SUBJECT: WATTS BAR NUCLEAR PLANT - RESPONSES TO REQUEST FOR
ADDITIONAL INFORMATION (RAI) REGARDING TRITIUM PRODUCTION -
INTERFACE ITEM NUMBERS 1, 6, 7, 10, 11, AND 12 (TAC NO. MB1884)

ENCLOSURE 1
TENNESSEE VALLEY AUTHORITY
WATTS NUCLEAR PLANT (WBN)
UNIT 1
DOCKET NO. 390
RESPONSE TO NRC REQUEST FOR ADDITIONAL INFORMATION

FIGURE 1
WBN ALLOWABLE SFP DECAY HEAT FOR
OFF-DESIGN SFPCS HX FOULING AND CCS TEMPERATURES

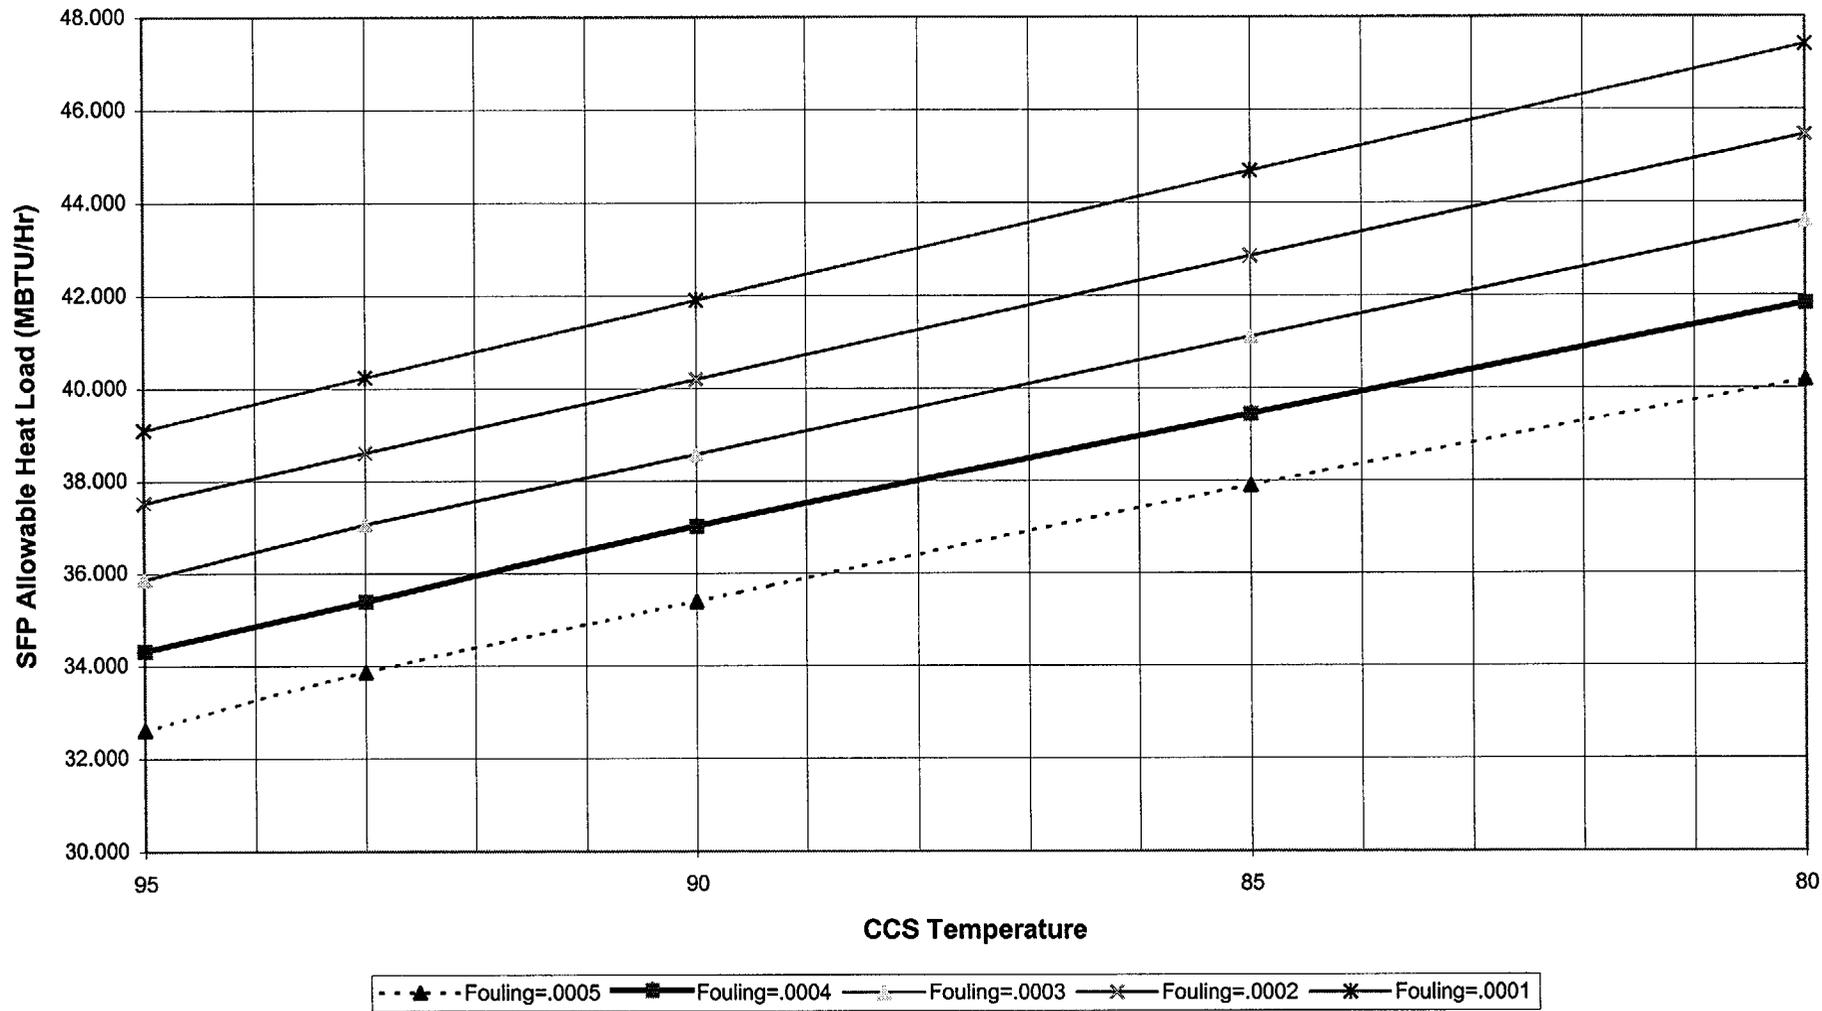
- c) In the subsection "Results of Alternate Analysis", TVA states that "series of curves have been developed to provide operator guidance for an increase in allowable SFP decay heat." What criteria were used to determine the allowable decay heat for the given heat exchanger fouling and CCS temperature when preparing the curves? Is each point in the curves the maximum decay heat which would maintain the SFP temperature below 159.24°F for the given heat exchanger fouling and CCS temperature? Please provide this graph.

The Alternate Analysis developed data for the curves by placing just enough decay heat load into the SFP that would result in a maximum SFP temperature of 159.24°F, assuming one failed train of SFP cooling. Multiple analyses were performed at varying fouling factors, ranging from 0.0001 to 0.0005 and varying CCS Temperatures between 95°F to 80°F. As expected, at lower fouling and lower CCS temperature, a higher quantity of SFP decay heat could be input without exceeding the design limiting SFP temperature of 159.24°F. The resulting data was reduced by 2% to include margin, and the reduced data points were subsequently graphed (See attached Figure 1.) to allow a varying maximum SFP decay heat based on actual fouling and CCS temperatures.
